## City of Sugar Hill Planning Staff Report VAR 16-005

DATE:June 27, 2016TO:Mayor and City CouncilFROM:Planning DirectorSUBJECT:Variance Request VAR 16-005 | Stream Buffer Variance

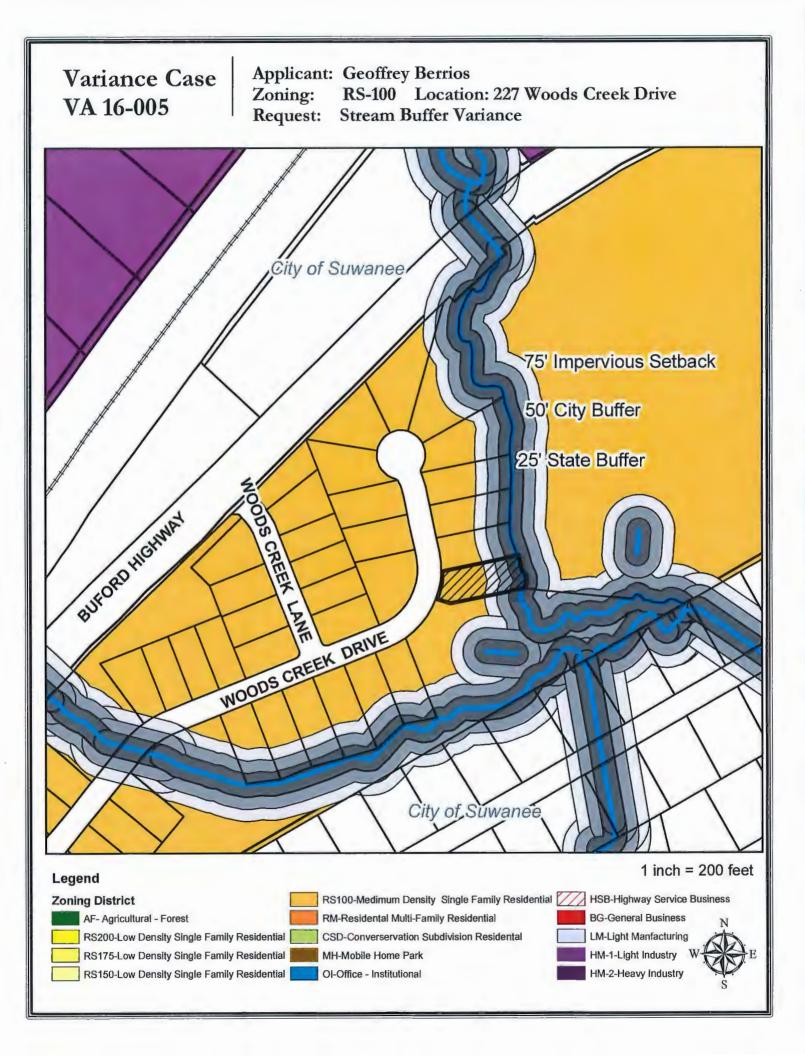
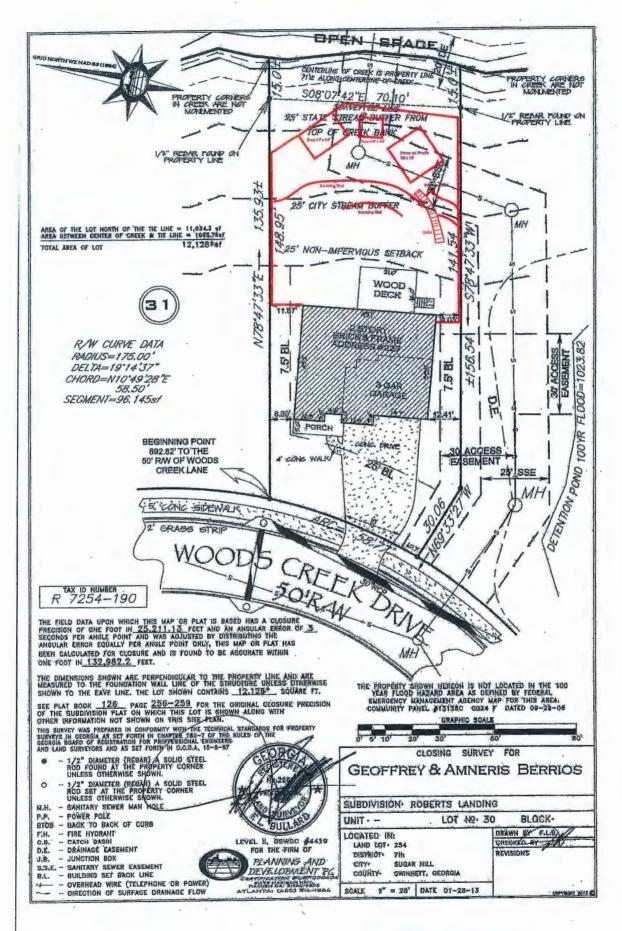
The shed and pavers will include 486 square feet within the 25' city and 25' state undisturbed buffers. In addition, the stairs will be approximately 100 square feet within the 25' city buffer and 25' non-impervious buffer. The fence will encroach upon approximately 200 linear ft. of all three buffers, and the retaining walls will encroach upon approximately 120 linear feet of non-impervious and city buffers. The existing house was built outside of the buffer; therefore, the property is usable without the variance.

The applicant indicates that the shed could not be located elsewhere due to the topography of the lot; however, it appears the shed could be located on the upper portion of the lot nearer to the house or that the fire pit and shed could be located within the 25' non-impervious buffer rather than within the two buffers closer to the stream.

Issuance of the variance would not help to protect natural resources. Rather, it could contribute to erosion, eliminate riparian wildlife habitat, and reduce the tree canopy, among other impacts.
